**Re. FCC ID:**  
**Applicant:**  
**Correspondence reference number:**  
**731 Confirmation number:**

**QLASH1GHZ**  
**Mala GeoScience AB(publ)**  
**26042 and 26041**  
**EA827998**

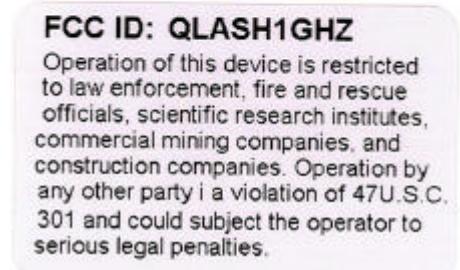
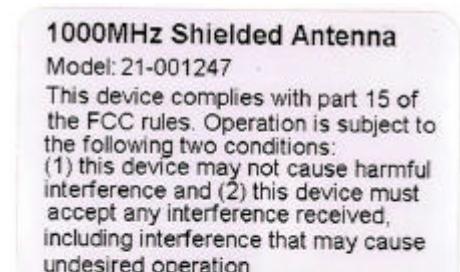
The FCC ID is not shown on the identification label. Submit a revised identification label showing the FCC ID pursuant to Section 2.925(a) of the FCC Rules.

New document “Idlabel ver 2.pdf” with description “New id labels and location” filed.

This document shows these pictures:

Picture 1. Text on labels

Picture 2. Labels on UWB unit
